To: Shay McDonald
From: Graeme Starke
Company: Otago Regional Council
SLR Consulting New Zealand Limited
cc: Brad Radloff
Date: 12 December 2025
Project No. 860.016676.00002
RE: Bendigo-Ophir Gold Mine - Air Quality Technical Review

Bendigo-Ophir Gold Project: Assessment of Environmental Effects from the Discharge of Contaminants to Air Peer Review Report

Figure 1: Location of Annual Herbs (extract from Section 8.5 (Figure 33) PDP, 2025)

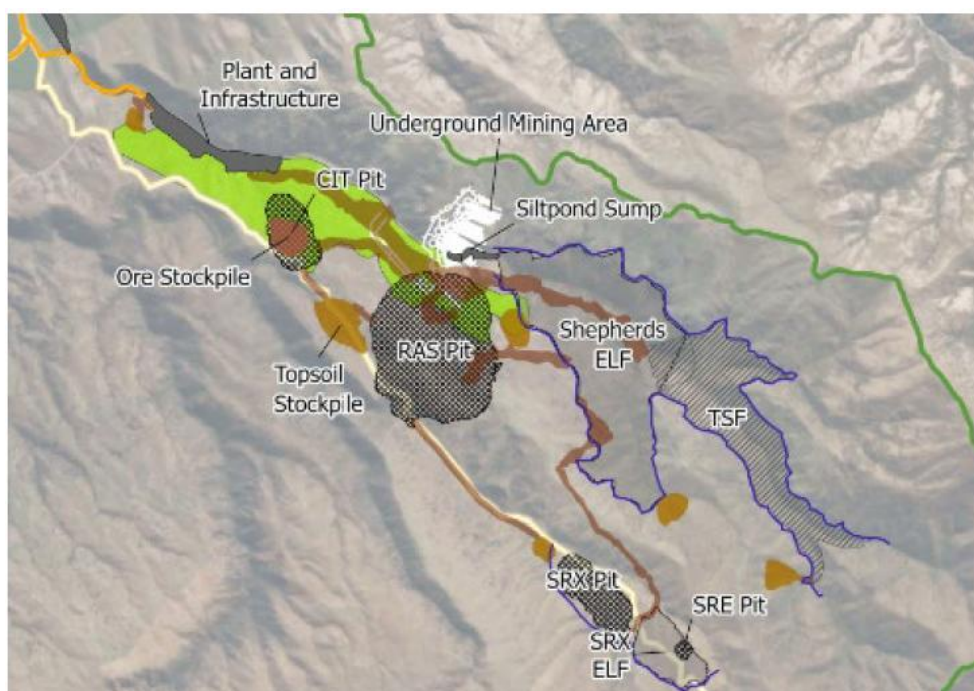
An ecologically sensitive receptor (annual herb) was identified as the vegetation type in and around CIT Pit, the Ore Stockpile and the Plant and Infrastructure Area (Figure 1).

SLR has assessed the PDP (2025) ecological impact assessment as reasonable based on the dust loading, vegetation type and rainfall within the area. In fact, the assessment is likely

conservative given the vegetation type being an annual herb. With annual herbs having a lifespan of less than one year (approximately 9 mths) and dust not having long periods of time to accumulate on leaves, the dust impacts are likely to be less than those stated in PDP (2025). A potentially greater threat than dust to the annual herb population is clearing more impact assessed and sediment runoff from cleared and stockpile areas. The management controls associated with these issues should be managed as 'critical controls'.
